MARIN COUNTY FLOOD CONTROL AND WATER CONSERVATION DISTRICT
GALLINAS LEVEE UPGRADE PROJECT INITIAL STUDY
COMMENTS ON THE INITIAL STUDY AND RESPONSES

1. Comments on the Initial Study and Responses

Figure 1: Current View, 623 Vendola Drive

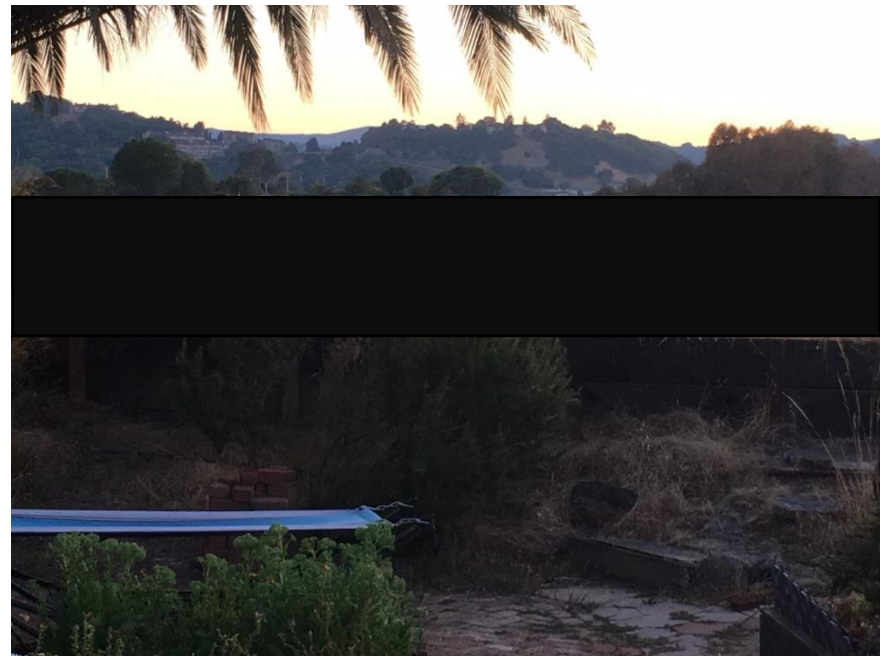
Figure 1 shows the current view from our living room, showing the TRB and the currently unobstructed view of the trees and hills beyond. The area across the creek appears from our vantage point to be parkland. We purchased the home at a significant premium due to this unobstructed view. The height of the current TRB at our property is 2 feet, and the top of the berm is at approximately 10 feet.³ Thus, under the proposal, the County could raise the TRB by up to 2.5 feet at our property. Figure 2 shows what the view would look like from our home with an additional 2.5 foot berm. That degree of increased height almost eliminates the view from our home. Thus, based on the Lewis 2018 estimate above, and our current home value estimate of \$924,500⁴, our home value would be reduced by between \$46,000-92,000. This does not consider the additional loss of real property due to the County easement.

For these reasons, Section 14 of the CEQA initial study requires revision to describe the economic impacts, to the residents along Vendola Drive, of the loss of views. The only way to mitigate these impacts is to construct a TRB that is no higher than necessary. For this reason, construction of a TRB that exceeds 11 feet would impose a significant social and economic impact on local residents without any mitigation or corresponding benefit (since Santa Venetia would flood anyway if the water exceeds 11 feet). For this reason, we request that the County (1) Correct the omission in the CEQA analysis, and (2) Limit the height of the berm to no higher than 11 feet.

- L-4 As noted in the response to comment J-3, Any design for levee height increase would have the effect of blocking some views from residences and backyards. As noted in that response, impacts on private views are generally not considered significant under CEQA. A slight decrease in property value that could result would not be expected to result, through a chain of cause and effect, in adverse physical changes. Furthermore, the value of all homes, not just those along the creek, that receive increased flood protection in the neighborhood would be expected to rise, as noted in the response to the previous comment. Economic impacts themselves are not considered in a CEQA review. The alternative means of reducing flood risk would be to raise the elevation of houses. This may also have the effect of

- improving views. Doing nothing to reduce flood risk would certainly result in a decrease in the value of homes in the neighborhood. With regard to the proposed design height of the TRB, please see the response to comment L-2.
